**PLANNING & ZONING COMMISSION ACTION ITEM
STAFF SUMMARY
AUGUST 5TH, 2020 REGULAR MEETING**

**A RESOLUTION APPROVING A LEVEL III DEVELOPMENT APPLICATION FOR A
MINOR AMENDMENT TO THE DILLON URGENT CARE AND RESIDENCES PUD
DEVELOPMENT PLAN.**

2020 Minor PUD Amendment Summary:

Proposed Building Cross Section

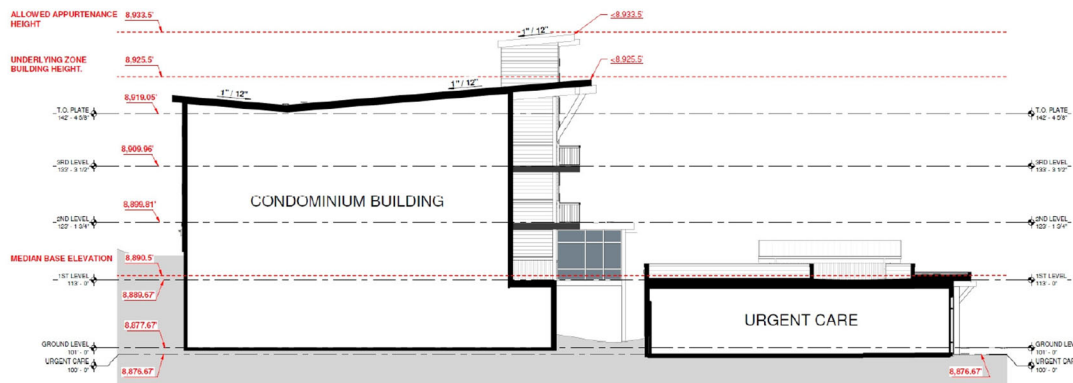
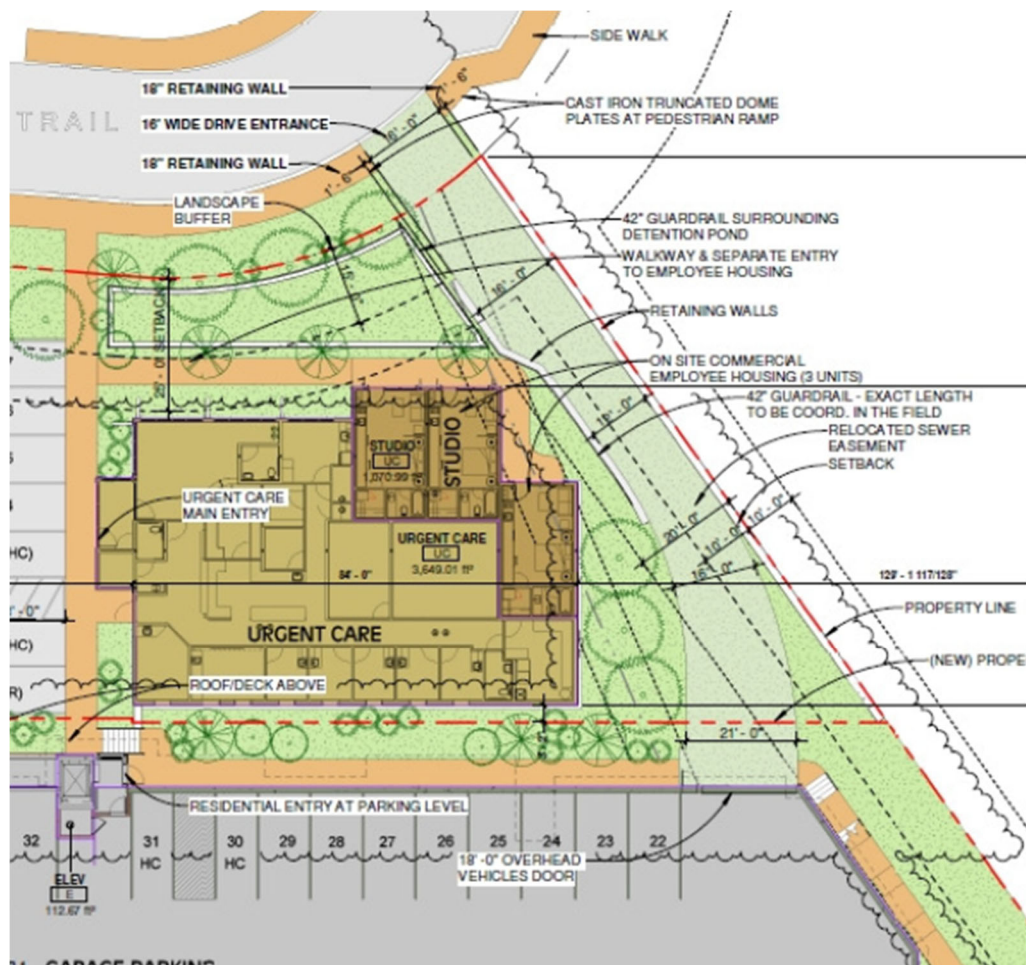
1) RAISE parking garage slab floor elevation. NO OVERALL HEIGHT CHANGE.

The applicant raised the finished floor elevation of the garage 4'. The applicant flattened the pitch of the roof and reduced the vertical spacing between floors in the Lot 45B residential building to keep the height of the building below the maximum height allowed by the Town municipal code in the Mixed-Use Zone district.

Roof Ridge Height: In both cases, the maximum height of the northern ridge line (shown on the right side of the cross sections) was held at an elevation of 8925.5', which is the maximum allowed height for the residential building.

Elevator Tower Height: The elevator tower maximum elevation does not exceed the approved elevation of 8933.5' in both instances. The top of the elevator tower is allowed to be an additional 8' above the maximum roof elevation in accordance with the Code.

Proposed Separate Driveway to the Residential Building

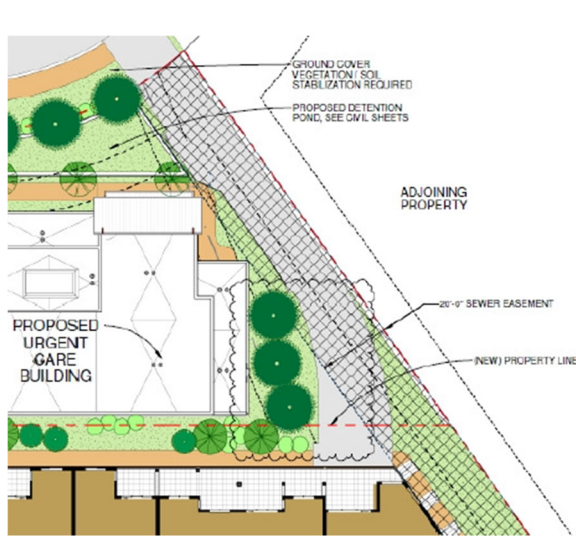
2) ADD a separate driveway to the residential building on Lot 45B.

As described above, the applicant raised the finished floor elevation of the garage 4', causing access through the clinic parking lot to no longer be possible. The applicant modified the site plan to create a new **separate residential driveway** to the northeast corner of the condominium building, along the eastern property line adjacent to the Dillon Dam Brewery development. This driveway will only serve the residential building. The garage access through the clinic parking lot to the northwest corner of the residential building has been eliminated.

The new driveway will be constructed over the new 20' wide sanitary sewer easement located along the eastern property line. From a sanitary sewer maintenance, grading, and access standpoint, this arrangement is desirable to the Town.

A small boulder retaining wall will be built along the Dam Brewery property line and the road will sit below the elevation of the shared property line. This arrangement will prevent snow from being plowed onto the Dam Brewery property.

Proposed Driveway showing Landscaping

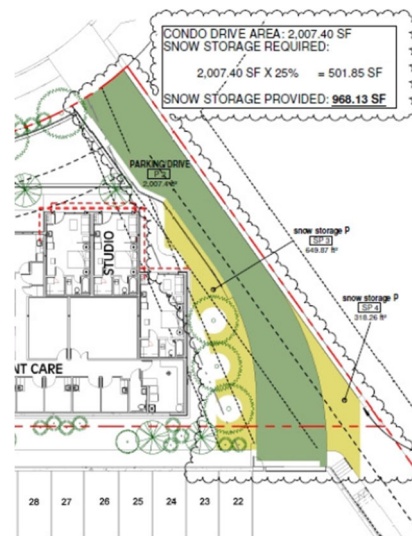
The 20' wide sewer easement along the east property line (along the Dam Brewery) prevented trees from being planted within the 20' easement. The trees near the new garage entrance locations were shifted to the west into the area between the new driveway, clinic building and residential building.

Proposed Revised Residential Garage Parking Lot Configuration

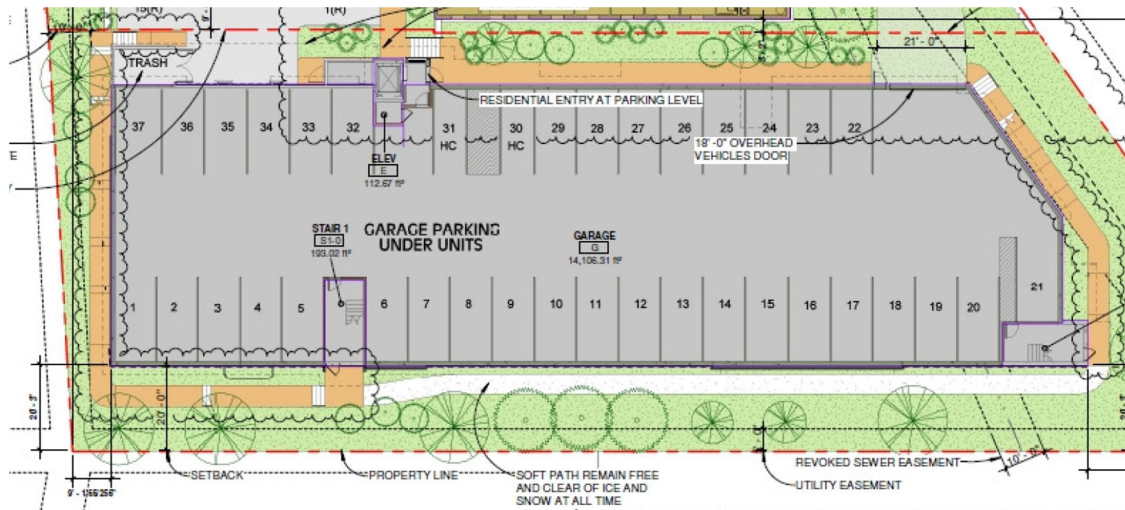
The Garage Floor Parking Layout was reconfigured to accommodate the new location of the separate residential driveway at the northeast corner of the building. The parking lot layout is more efficient and provides a total of 37 parking spaces, which provides one additional space more than the approved plan total of 36.

Note: The residential garage connection through the Urgent Care Clinic parking lot has been eliminated.

Proposed Sidewalk between buildings

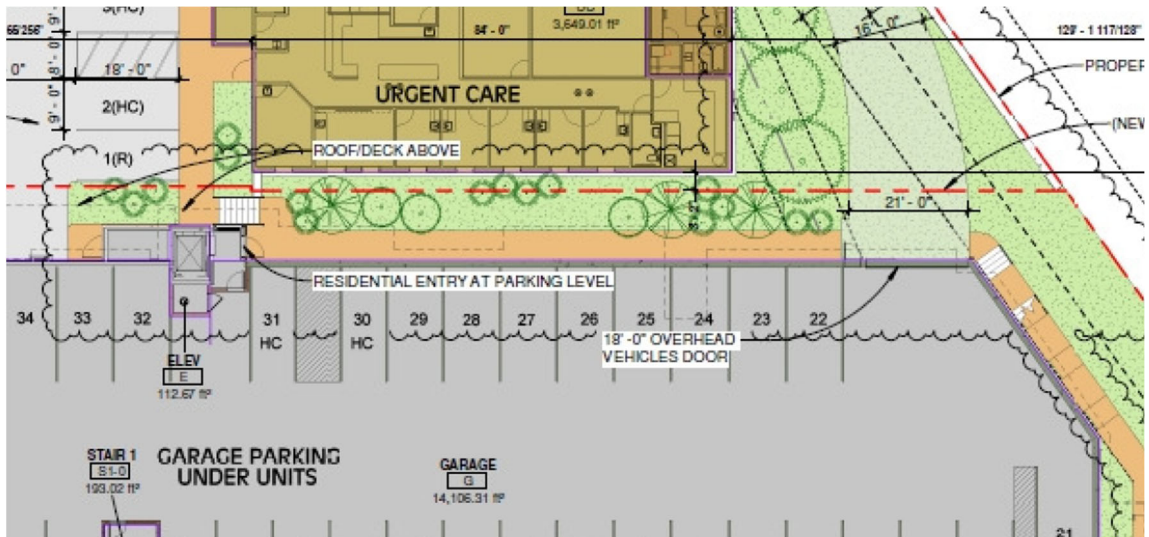
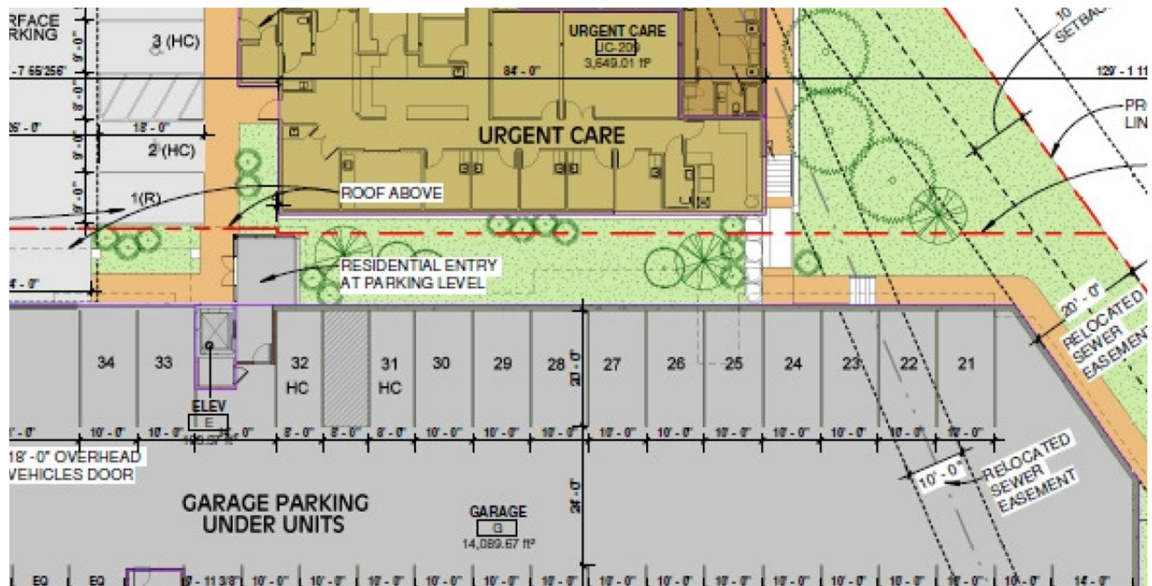
3) ADD a sidewalk on Lot 45B between the two buildings for better internal circulation.

The applicant reduced the size of the elevator entry area to the residential building and designed a new sidewalk along the northern side of the building to connect the separate garage entrance back to the elevator on the outside of the building. Some of the trees were shifted towards the urgent care building to make room for the residential driveway. **No trees were eliminated.**

Proposed landscape plan (44 Trees)

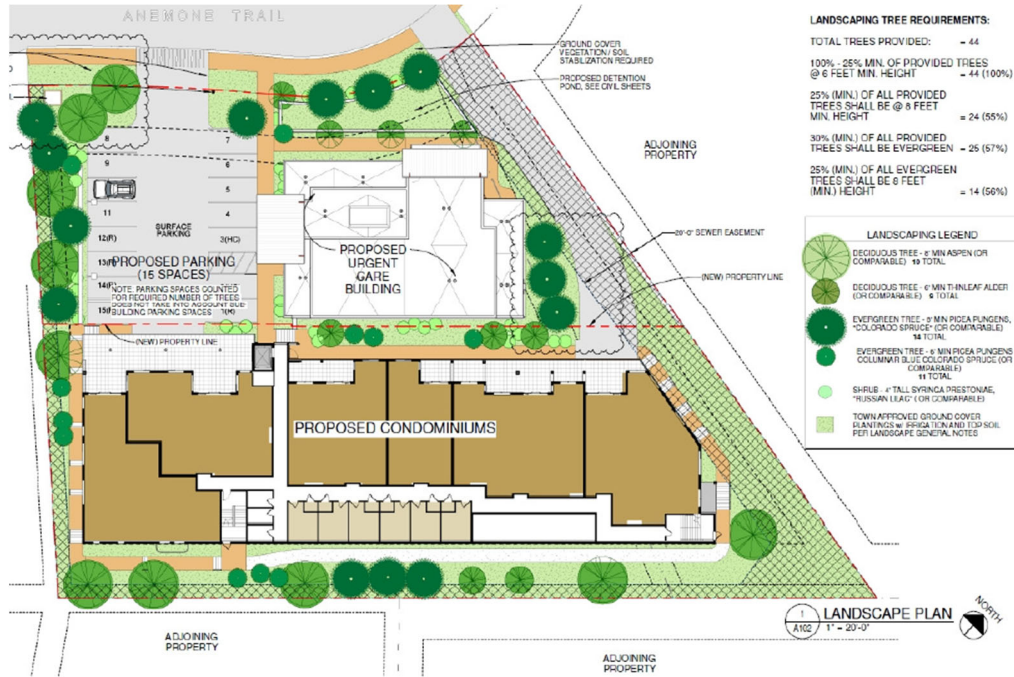
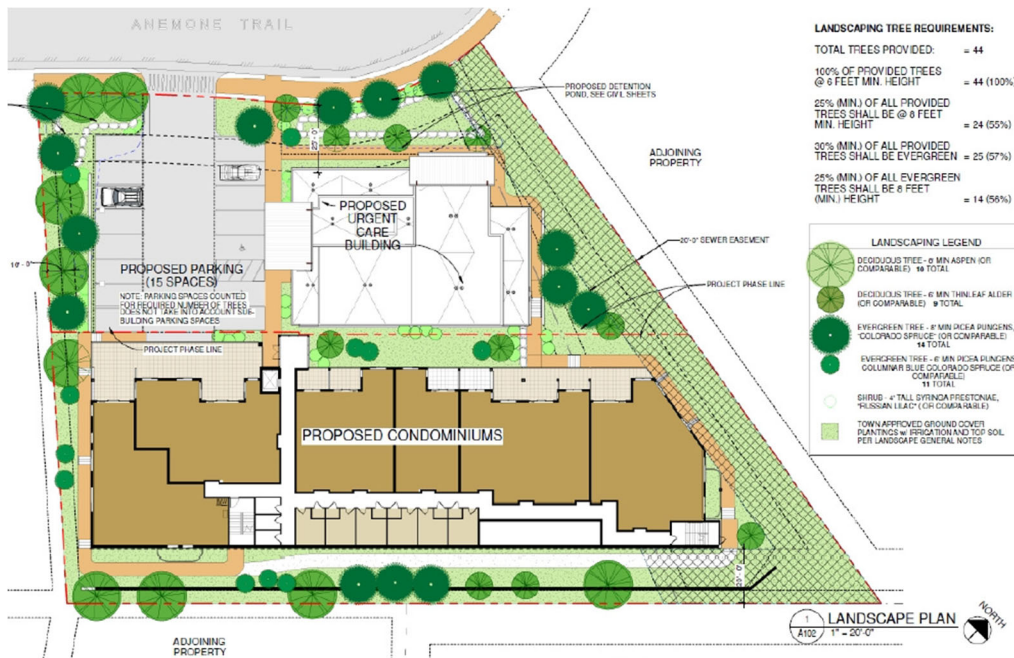
4) REVISE site grading, landscaping and utility plans.

The landscape, site, grading and utility plans will be adjusted to accommodate the new driveway and sidewalk layout. The corresponding landscape plans are shown below for comparison. It should be noted that no trees were eliminated and the new and existing landscape plans each provide a total of 44 trees. Trees were shifted to accommodate the site plan changes. The number of large street trees were also preserved in the revised plan.
